**ADDENDUM NO. 1**

Date: May 28, 2021

Bid Name Loblolly Woods Park Boardwalk Reconstruction

Bid No.: WSPP-210047-DM

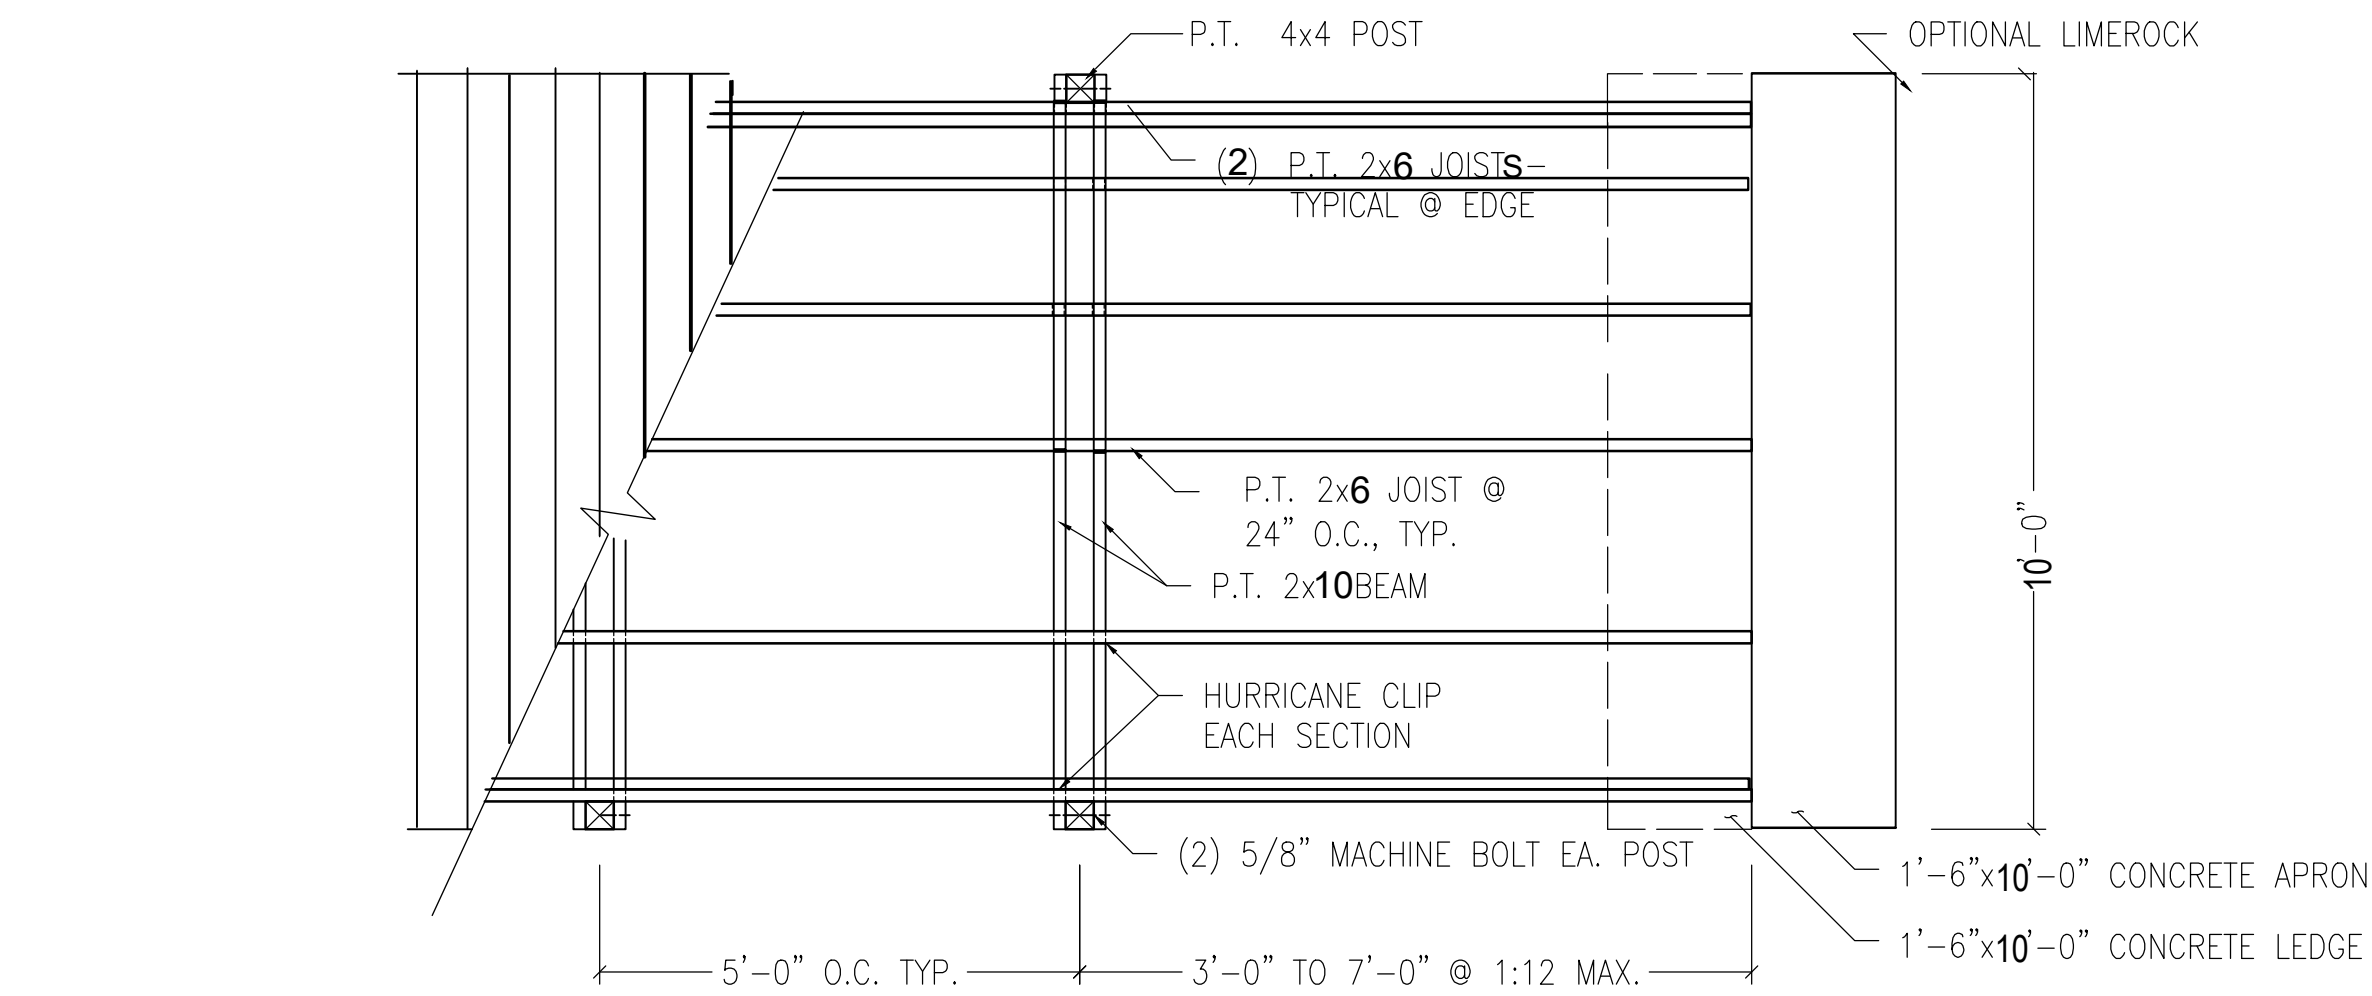
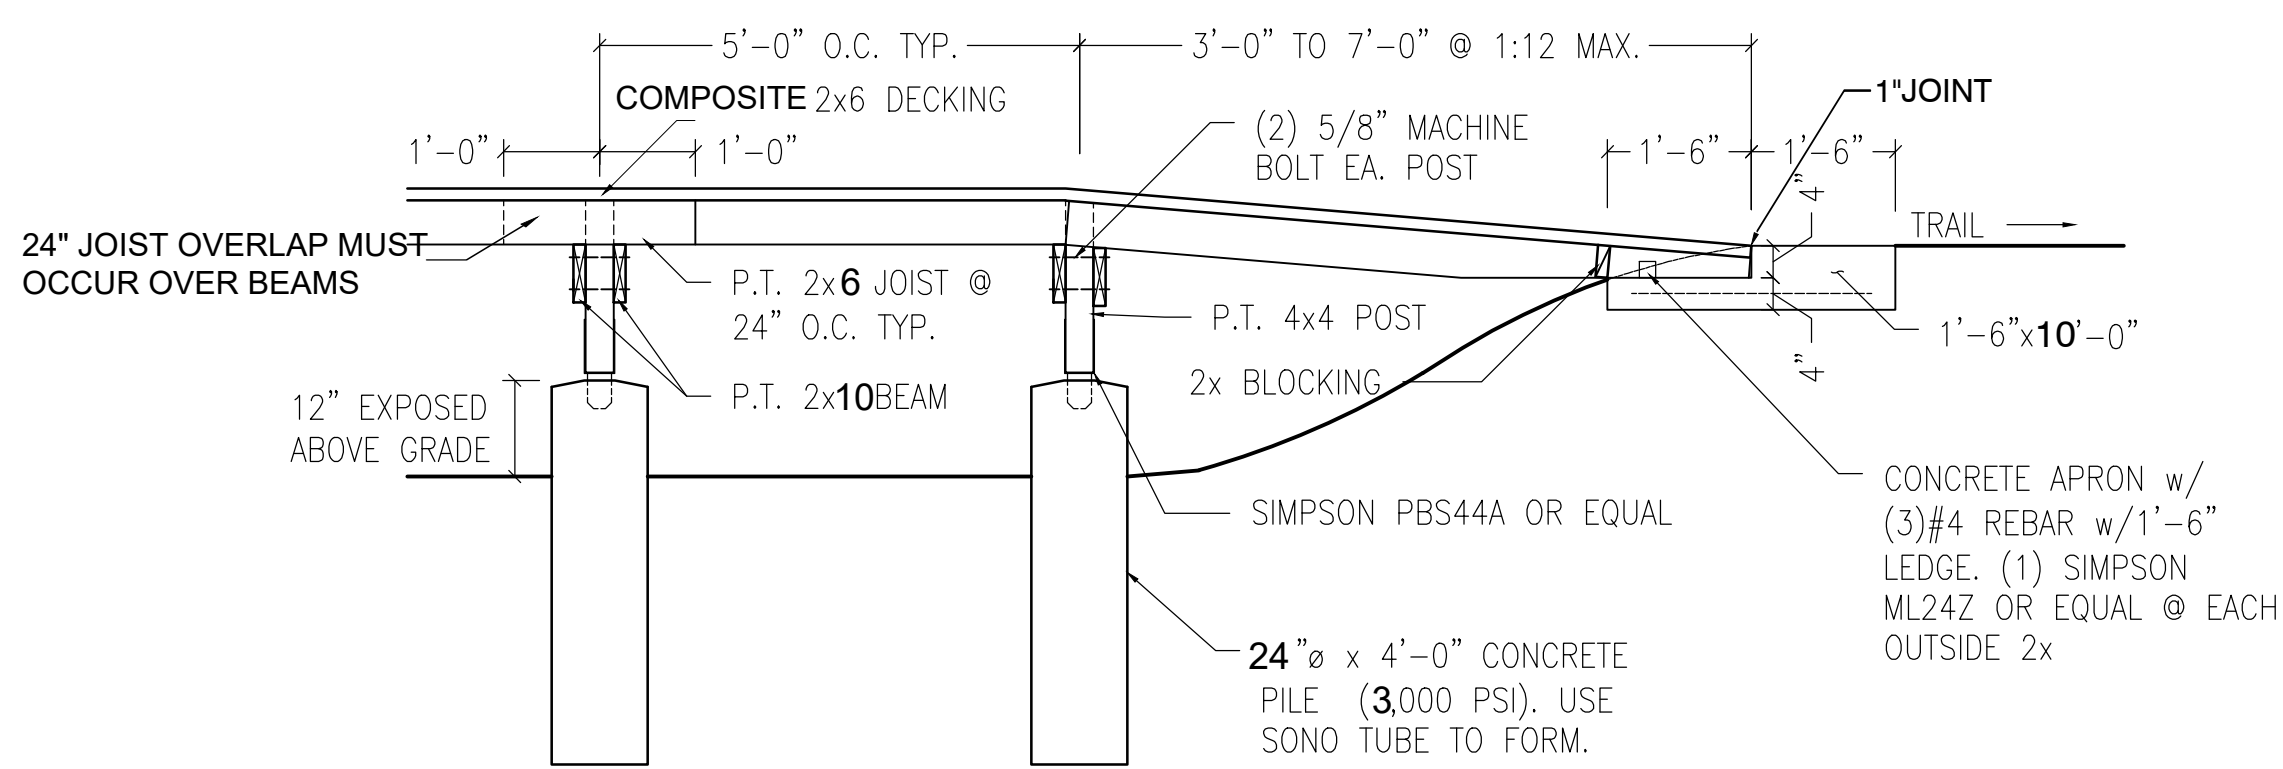
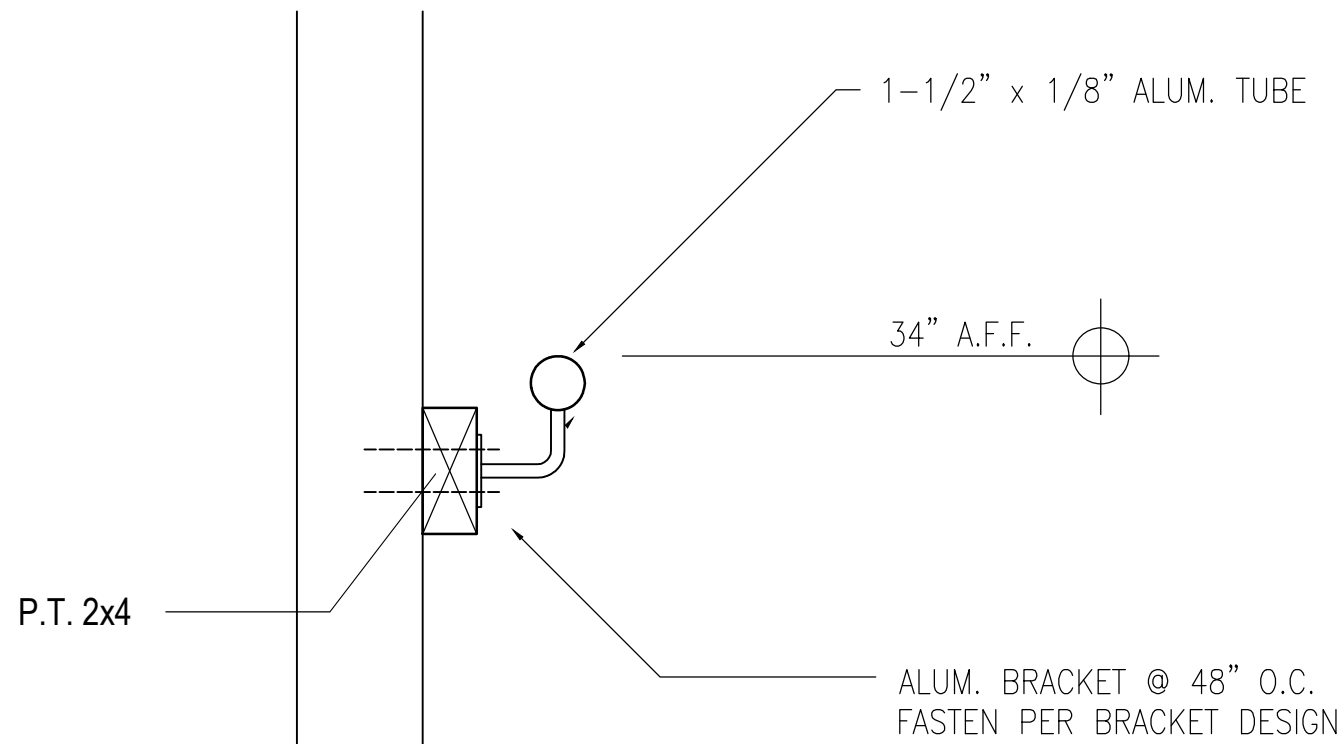
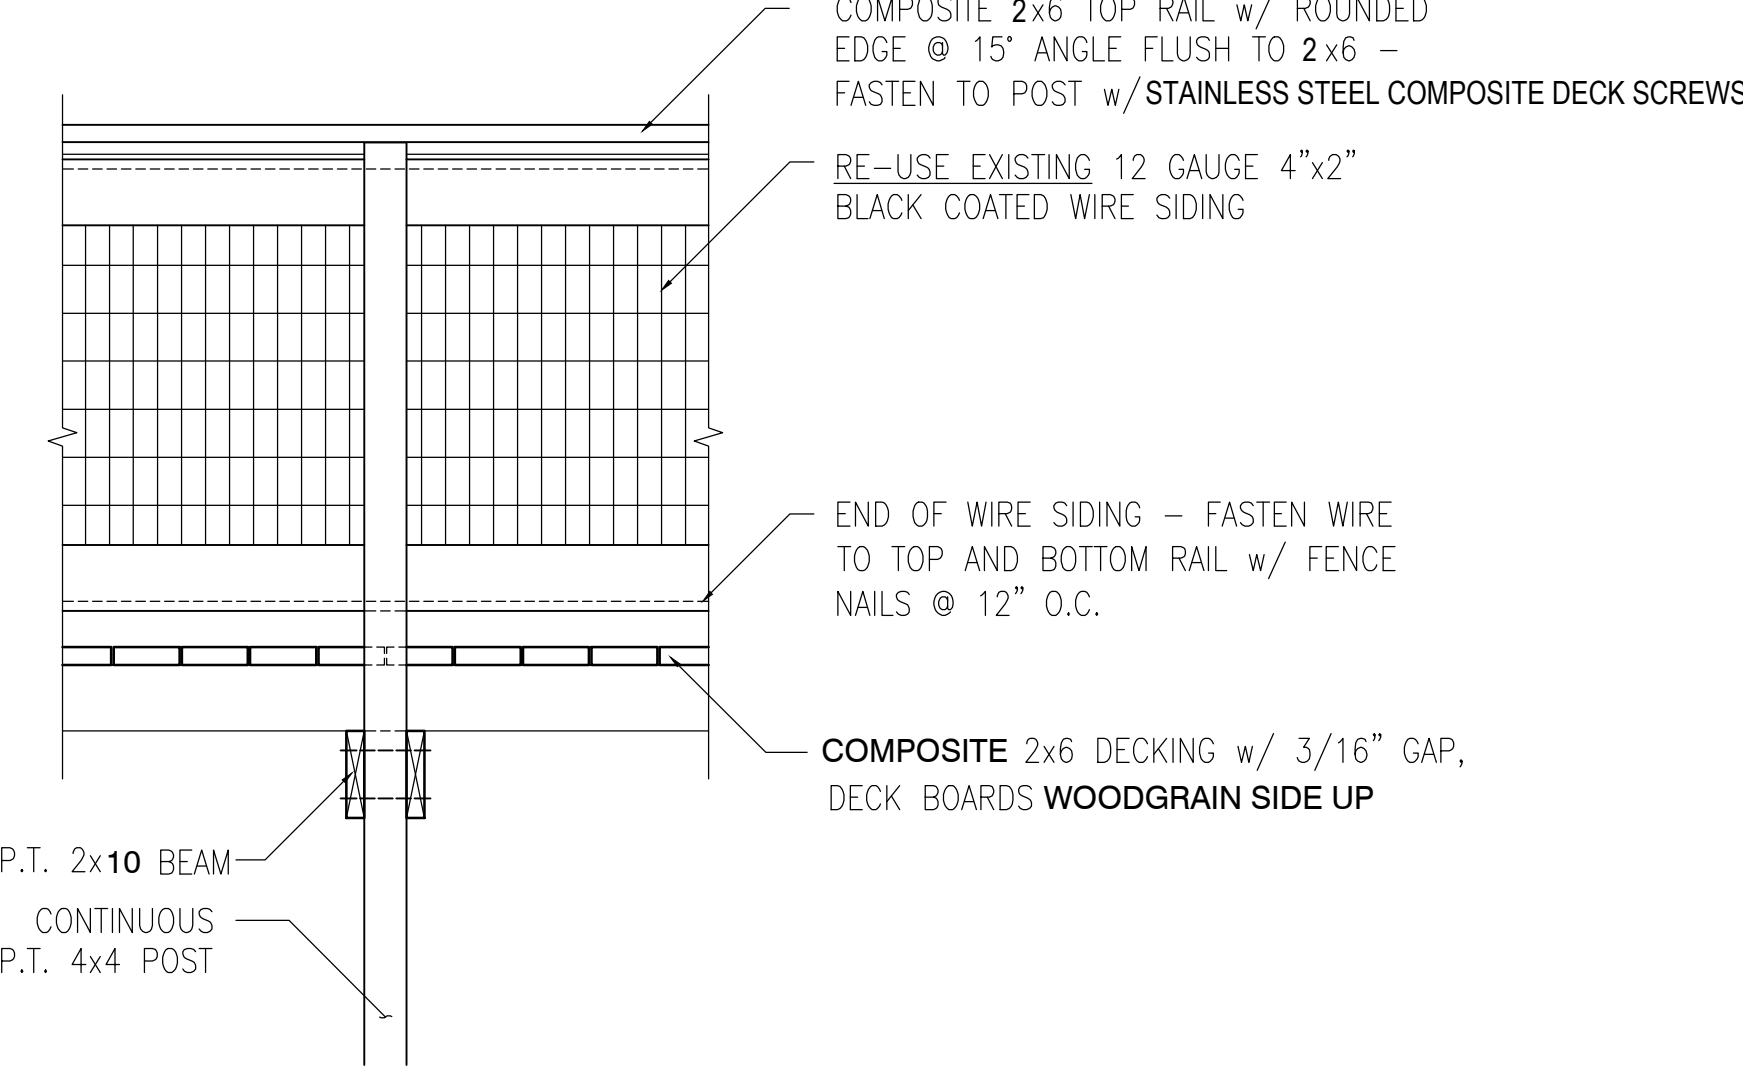
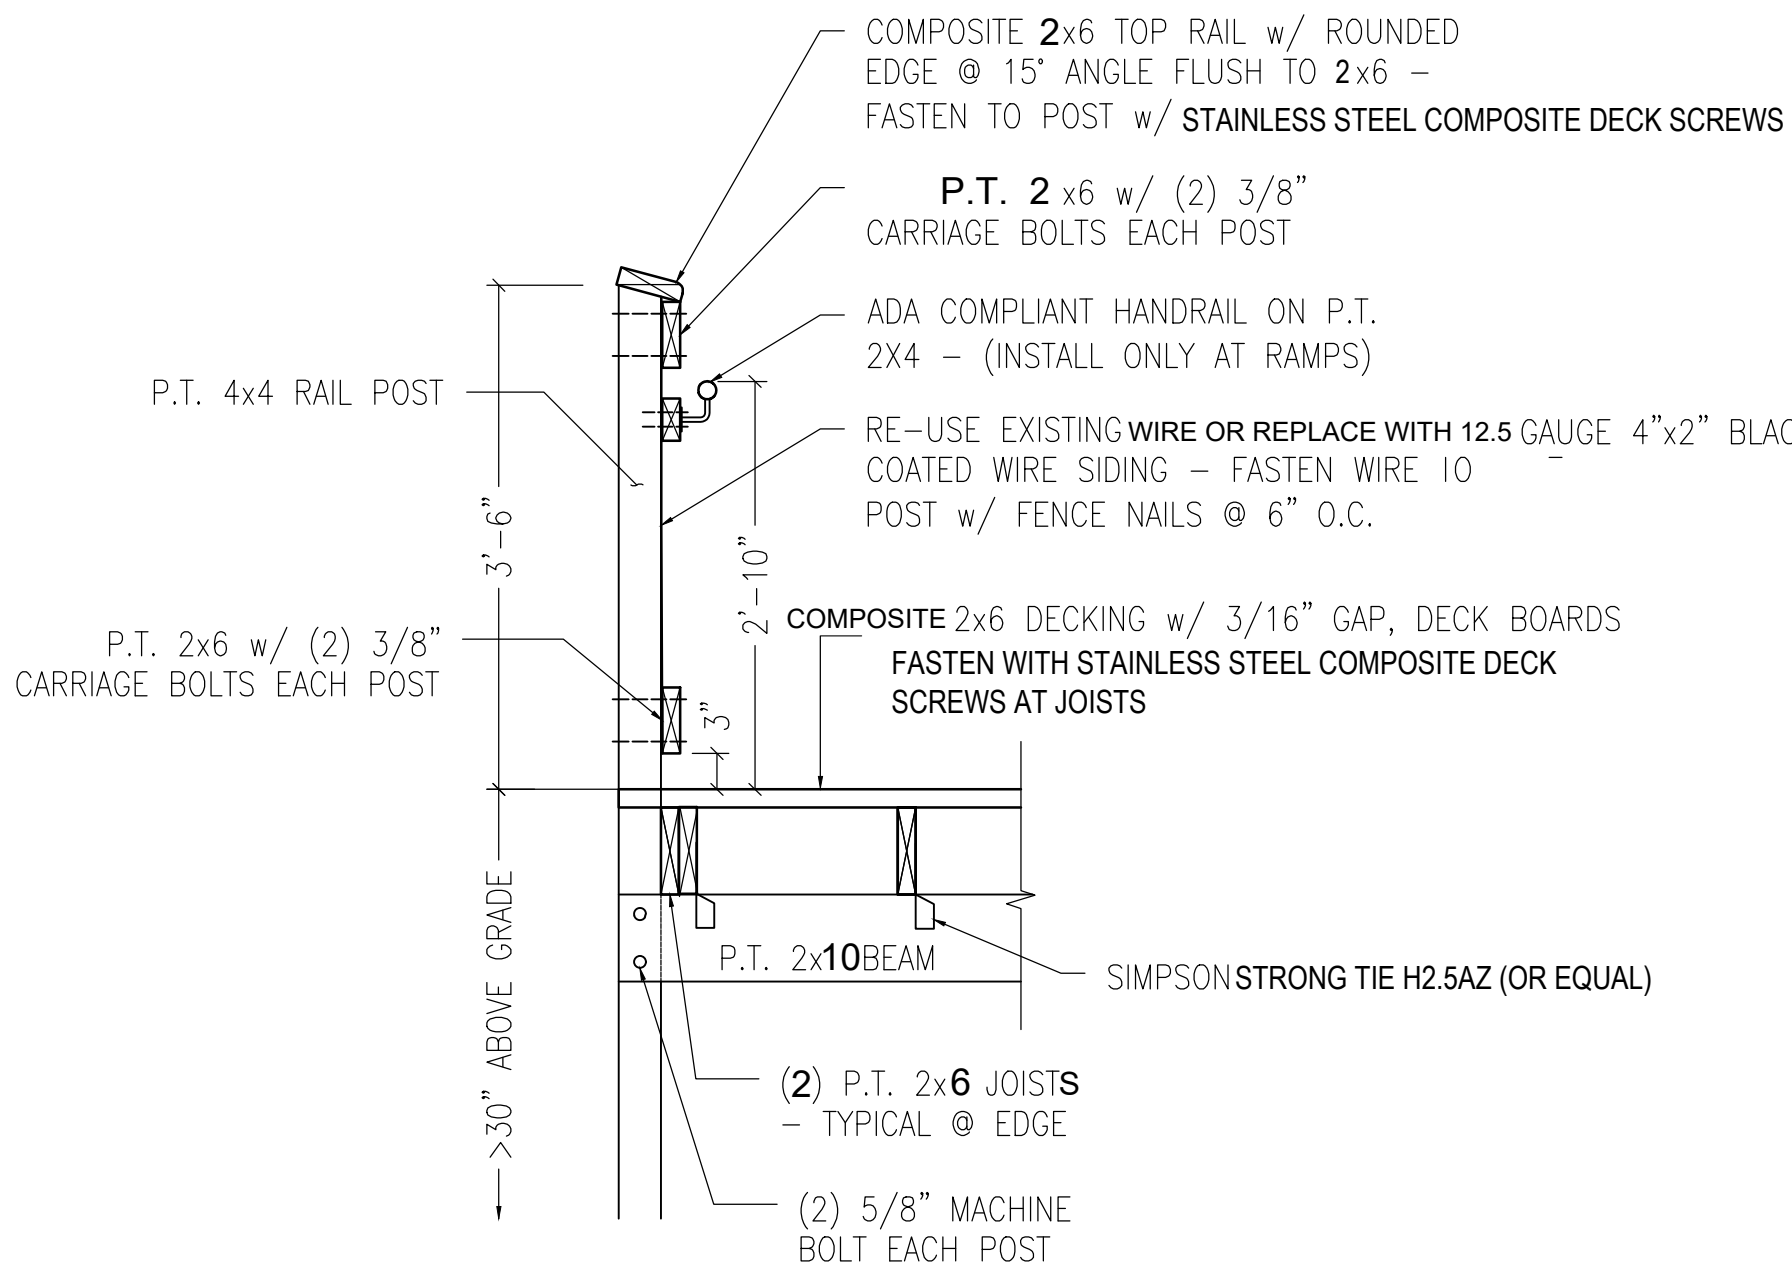
13. Question: The plans show a single joist, but the existing joist is double.  
Answer: Revisions have been made to Sheets S-2 and A101 – See attached.
